# ARIZONA DEPARTMENT OF ENVIRONMENTAL QUALITY

June 22, 2015  
FPU15-273

RE: WAFB – ADEQ Evaluation of USAF Response to ADEQ Comments; Weekly Progress Report April 27, 2015 and Progress Report May 4, 2015; Steam Enhanced Extraction at the Former Williams AFB, ST012 Site, Mesa, AZ; ADEQ document dated May 14, 2015

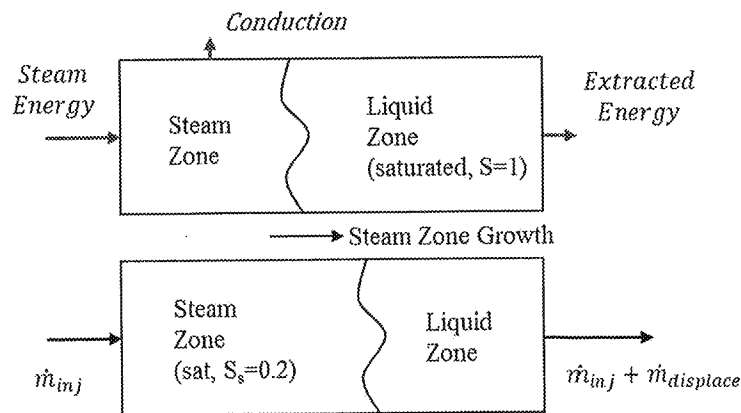
*Because the steam condenses, there is no reliable way to calculate or measure the actual steam volume in the formation.*

This is contradictory to the statement in the SEE Work Plan, Appendix D, p10,

“The injection of steam is a stable and predictable process. The steam propagation is governed by heat transfer to the formation, which has been studied intensively for oil recovery and has been applied to remediation applications for over 20 years.”

A straightforward method to estimate steam zone volume and growth during injection is provided in the attached document, “Evaluation of Hydraulic Containment during Steam Enhanced Extraction.” The method has been published in numerous references over the last 50 years (e.g., Marx & Langenheim, 1959; Mandl & Volek, 1969; Yortsos, 1982; Menegus & Udell, 1985). Application of the method to ST012 is also provided in the TEE Pilot Study Work Plan, Appendix C and in the TEE Pilot Study Evaluation Report, Appendix I. Use of the method as input to MODFLOW for assessing hydraulic containment is provided in the TEE Pilot Study Evaluation Report, Appendix H.

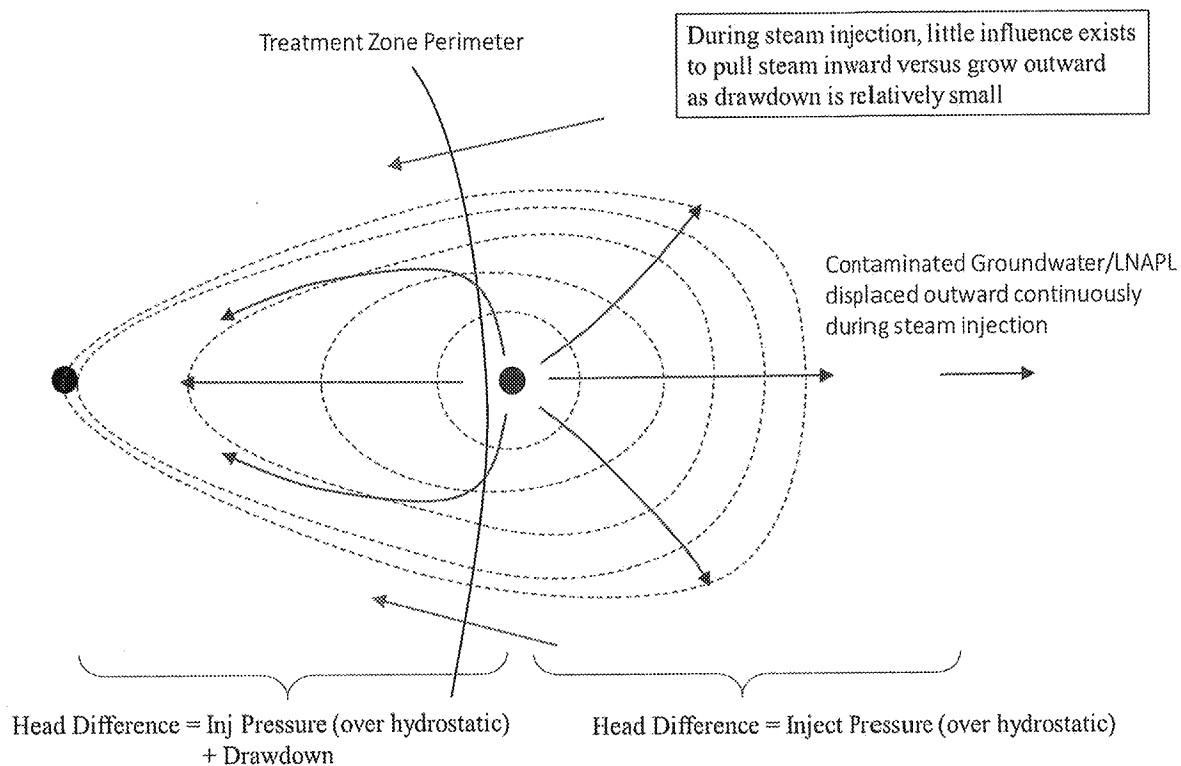
*TMP11 has a slight temperature increase at 175 ft bgs (currently around 50 C). This is probably due to influence by the nearby injection well UWBZ16 (80 ft away) and is expected.*

Figure 8 in the June 15, 2015 Weekly Progress Report shows 90 C at a depth of 170 ft bgs indicating the steam zone is very soon to arrive and move past this location far beyond the TTZ and beyond the defined HZ of the UWBZ. No mechanism exists to recover NAPL mobilized away from the TTZ in this area.

## Perimeter Steam Injection

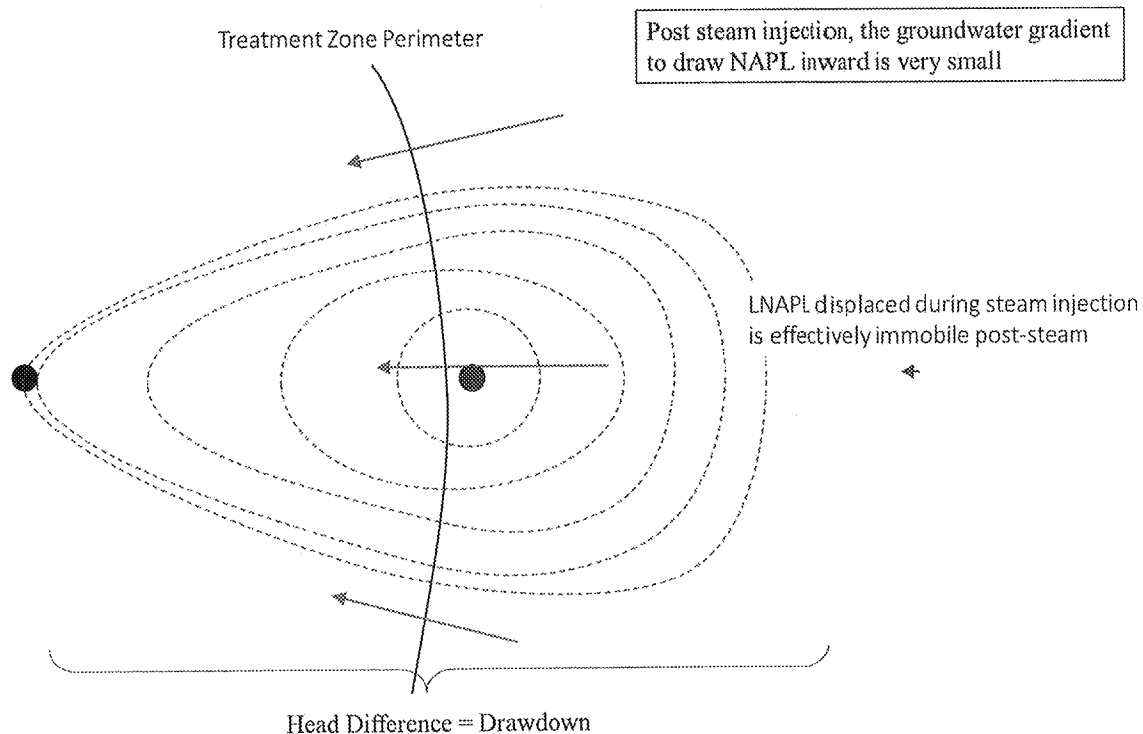
*We are currently building up the steam bubble in the UWBZ. The operational plan for the site is for perimeter steam injection wells to sweep steam out and around the injection wells and push inward to the outermost extraction wells (TerraTherm Design for SEE Treatment). Once we have steam breakthrough at the MPE wells, we will initiate pressure cycling where the steam bubble will be allowed to collapse or partially collapse, an inward gradient will be created.*

No mechanism or sufficient pressure gradient exists or will exist to recover NAPL mobilized away from the TTZ. Consider the pressure gradients illustrated below,

During steam injection, the drawdown pressure is small compared to the injection pressure and therefore only a small influence exists to pull the steam zone inward versus grow outward. Similarly, the steam zone pressure gradient to push mobilized NAPL at and beyond the TTZ perimeter is large compared to the extraction well gradient to draw the NAPL inward. When steam injection is ceased, the pressure gradient exerted by the drawdown and the collapsing steam zone is much smaller than the applied steam injection pressure gradient. As a result, NAPL pushed outward will not be pulled inward to extraction wells, the inward pressure gradient will be much smaller than the previous steam outward gradient. This rationale applies to perimeter injection in both the LSZ and UWBZ.
